Amendments to the 2002 Water System Standards

BOARD OF WATER SUPPLY

SUBJECT: 2002 WATER SYSTEM STANDARDS AMENDMENT

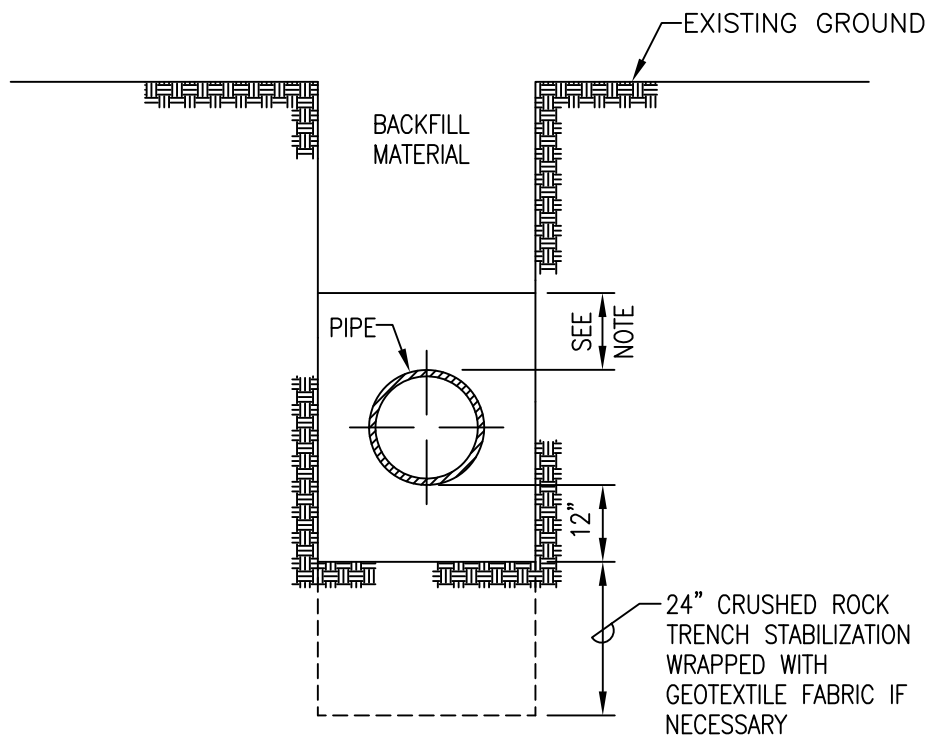
1. Delete Standard Detail P10 TRENCH BACKFILL and replace with the enclosed Standard Detail P10 TRENCH BACKFILL (2016 Revision) which reflects the increase in cushion material below the pipe to 12 inches.

METER SPLICE DETAIL

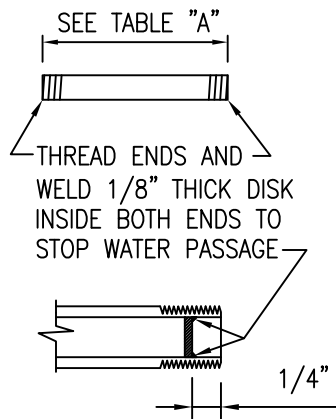
Replace the following details with the enclosed details (2014 Revision) which reflect the new splice length of 7-1/2" for a 3/4" meter:

TABLE "A"		
METER SIZE	SPLICE SIZE	SPLICE LENGTH
5/8"	1" DIA.	7 1/2"
3/4"	1" DIA.	7 1/2"
1"	1 1/4" DIA.	10 3/4"

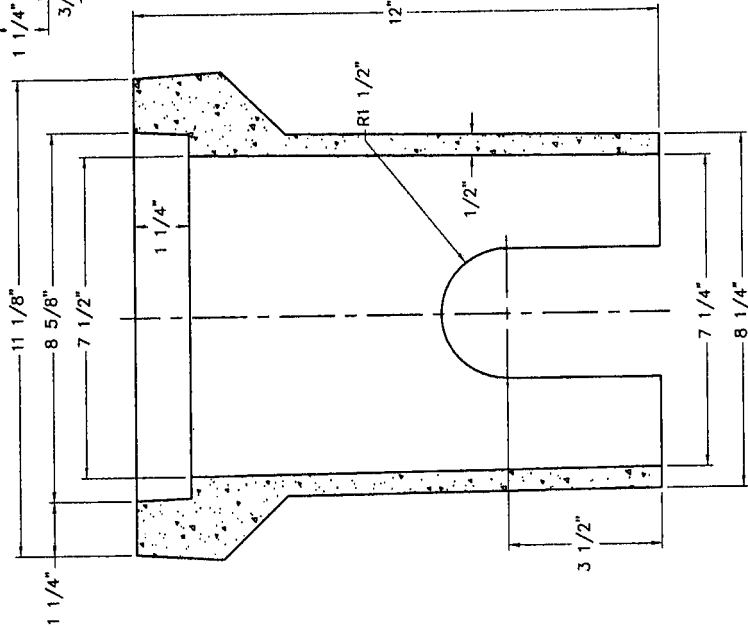
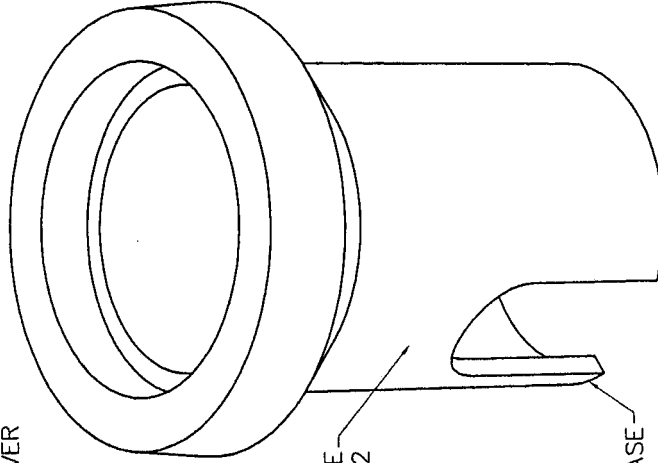
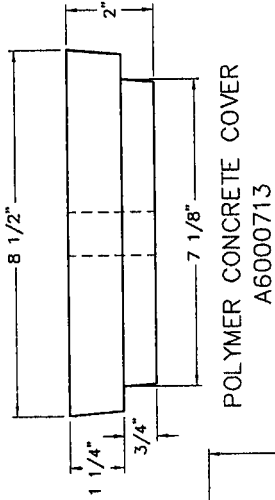
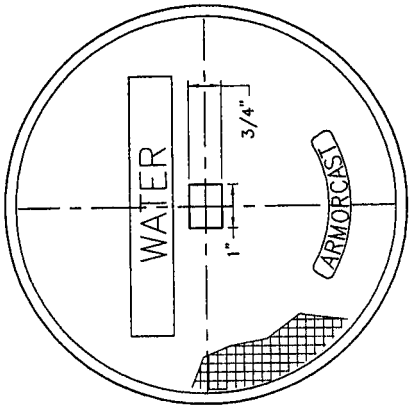
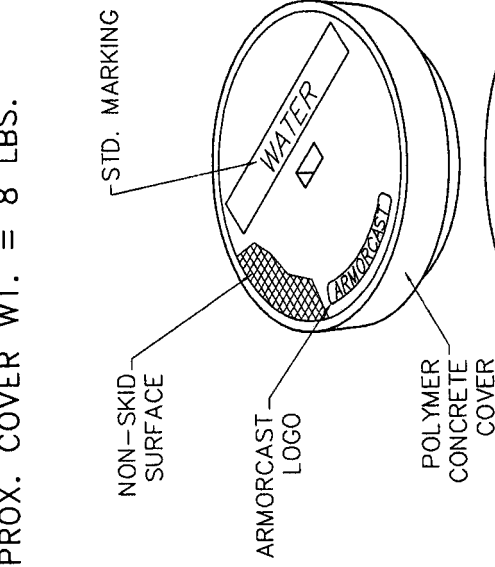
We approve the Armorcast Polymer Concrete Type "A" Valve Box (drawing no. A6000712TA) for inclusion into the Water System Standards for Oahu only.

8" X 2" FM METER & BOX LAYOUT FIRE AND DOMESTIC USES - CMU WALLS
SCALE: NTS

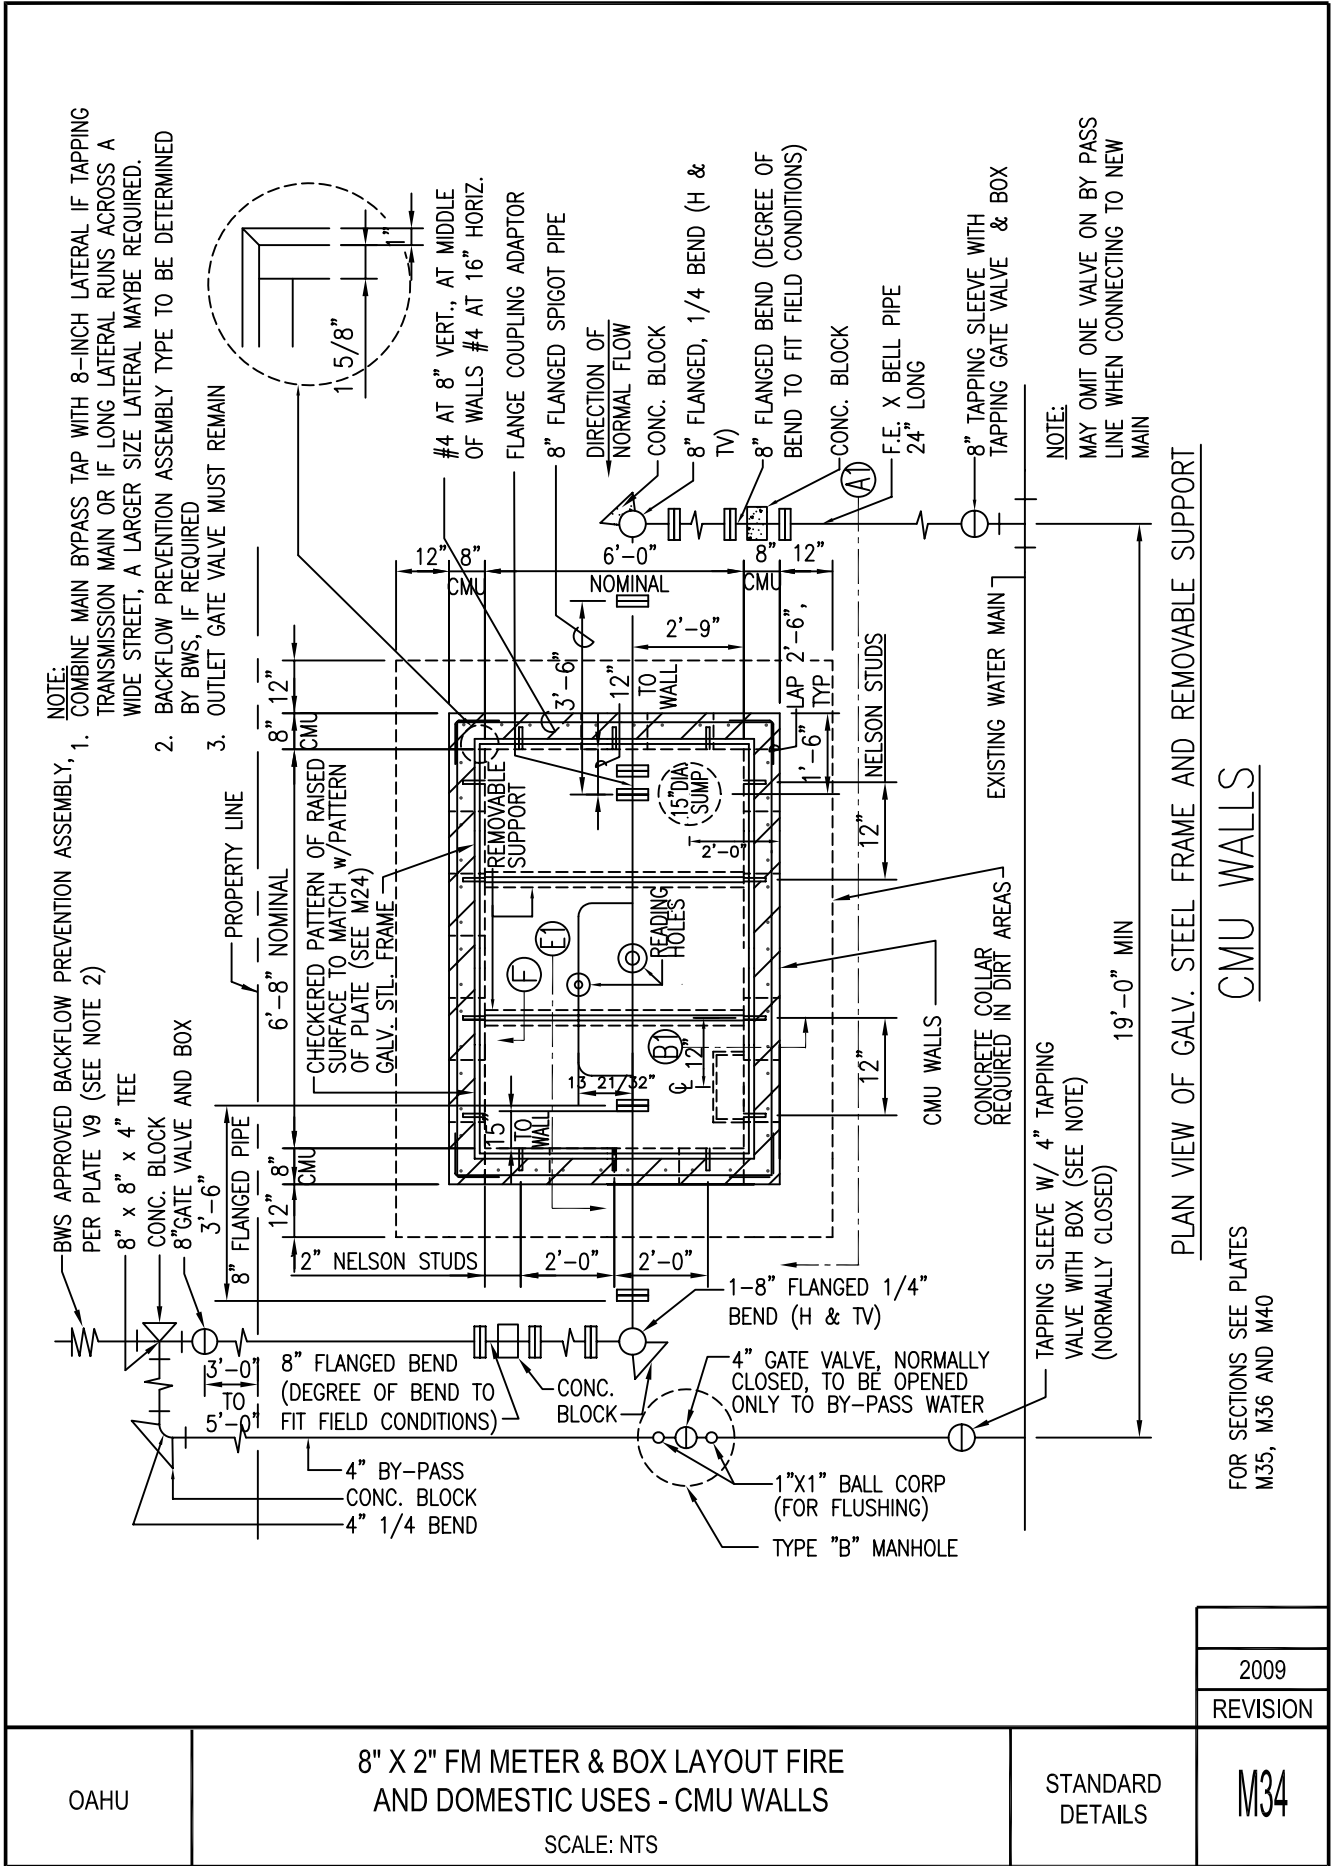
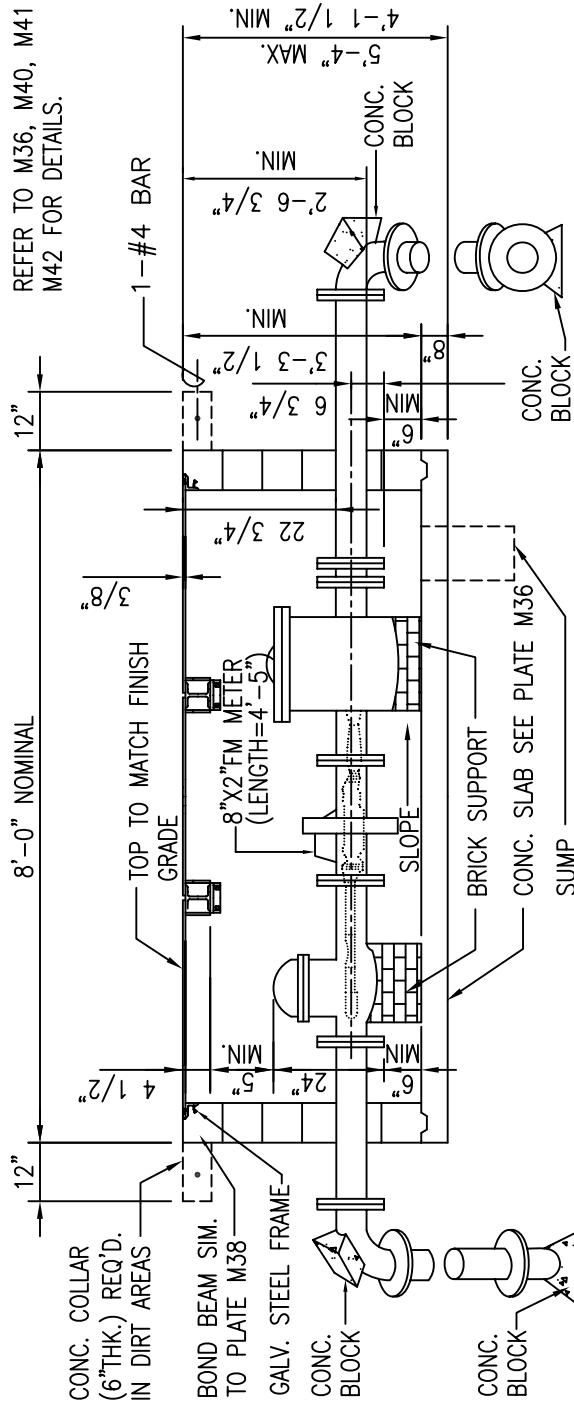
Replace the following details with the enclosed details (2009 Revision):

OAHU	COPPER SERVICE LATERAL FOR CONNECTION TYPE "X" METER BOX 5/8", 3/4", & 1" METERS SCALE: NTS	STANDARD DETAILS	2008
			REVISION
			L13

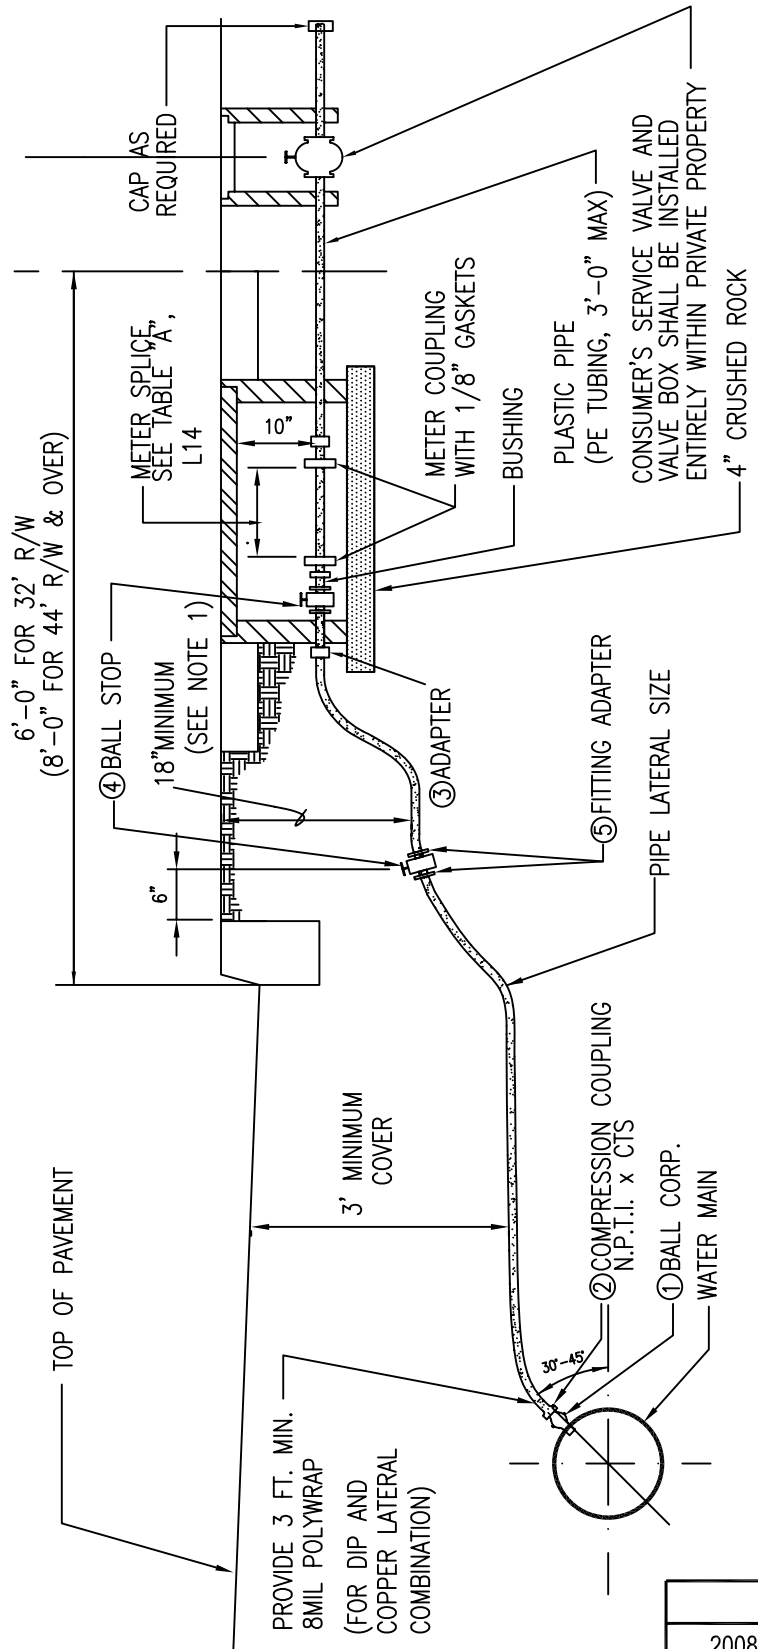
Replace the following details with the enclosed details (2008 Revision):

TYPE X COVER W/ CAST IRON READ LID

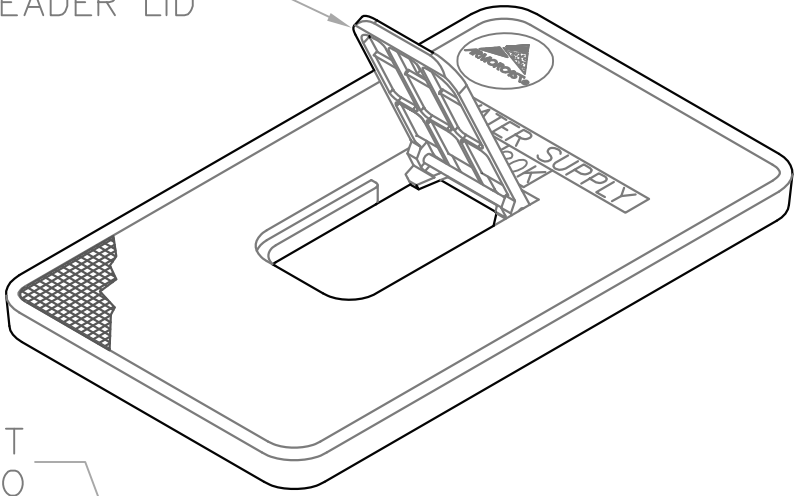
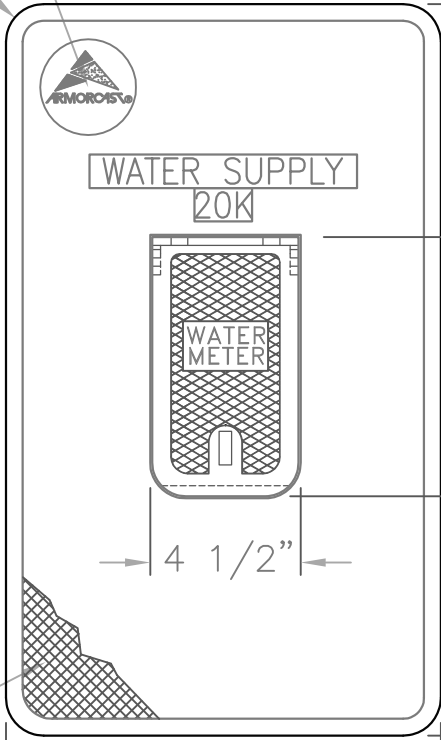
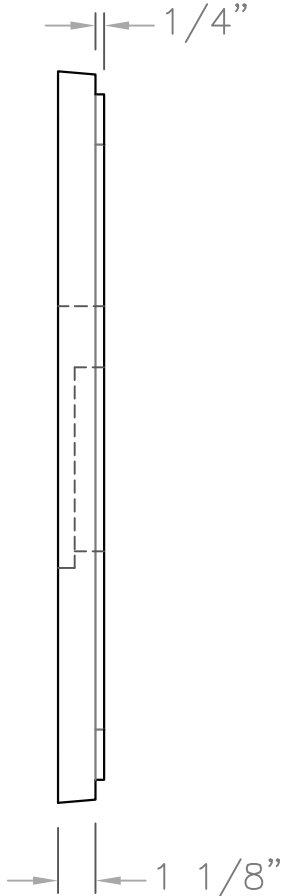
Effective immediately for Oahu only, all Polymer Concrete Type X Meter Box Covers shall be furnished with a cast iron reader lid as shown on the enclosed Drawing No. A6001869TRCI.
